Intel® 31154 133 MHz PCI Bridge

Specification Update

December 2005

Figure 1. Installing a Shottky Diode

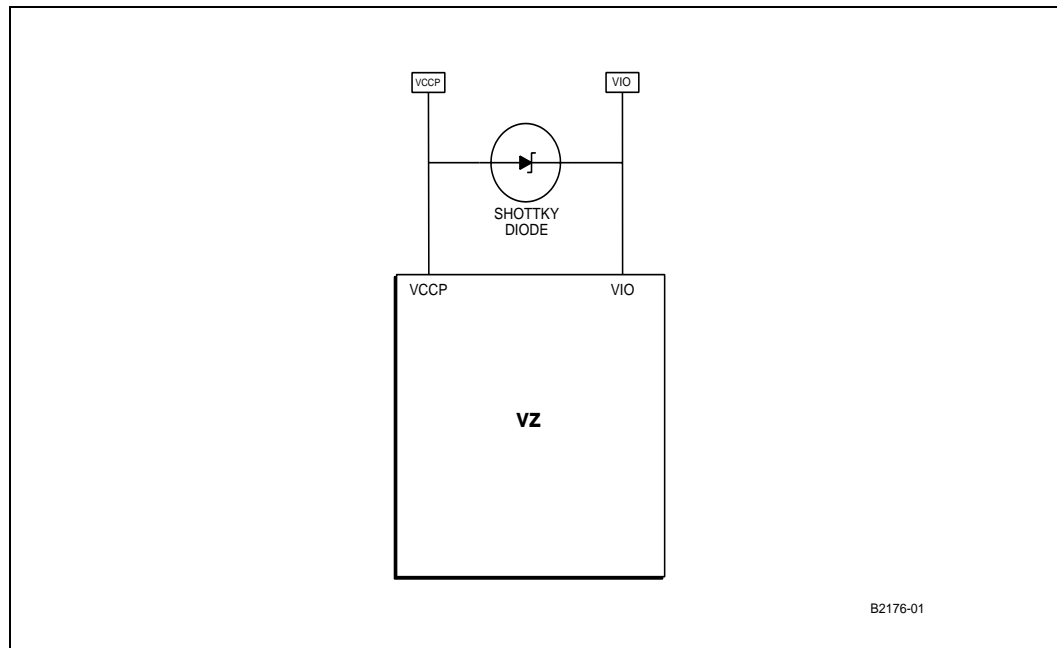
2. 31154 Power Supply Special Considerations

If either P_VIO or S_VIO is not connected to the same power supply as Vccp, the user must perform one of the following steps:

- Ensure that the P_VIO or S_VIO power comes up before or simultaneously with Vccp and ensure that the P_VIO or S_VIO power goes down after or simultaneously with Vccp.
- Install a Schottky diode, as shown in [Figure 1](#), between VCCP and the VIO pin/pins (as appropriate). The diode should be sized appropriately for the system's power environment. **(Recommended)**
- Connect a 250Ohm current limit resistor in series with the P_VIO and S_VIO supply. P_VIO and S_VIO can never be at a lower voltage than VCCP except in the case of a 250Ohm current limiting resistor in series with the P_VIO and S_VIO supply.

Figure 2. Installing a Shottky Diode

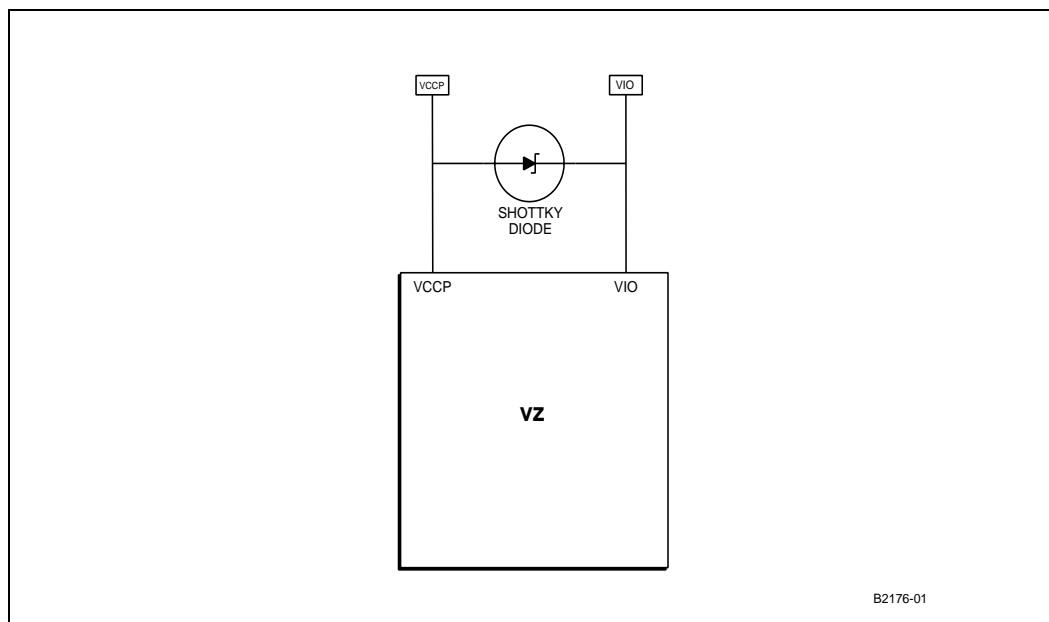
1. Power supply sequencing description incomplete.

Issue: The description for Section 3.4 does not fully describe the powering sequence for the 31154 Bridge. It should appear as follows:

If either P_VIO or S_VIO is not connected to the same power supply as Vccp, the user must perform one of the following steps:

- Ensure that the P_VIO or S_VIO power comes up before or simultaneously with Vccp and ensure that the P_VIO or S_VIO power goes down after or simultaneously with Vccp.
- Install a Shottky diode, as shown in [Figure 2](#), between VCCP and the VIO pin/pins (as appropriate). The diode should be sized appropriately for the system's power environment. **(Recommended)**
- Connect a 250Ohm current limit resistor in series with the P_VIO and S_VIO supply. P_VIO and S_VIO can never be at a lower voltage than VCCP except in the case of a 250Ohm current limiting resistor in series with the P_VIO and S_VIO supply.
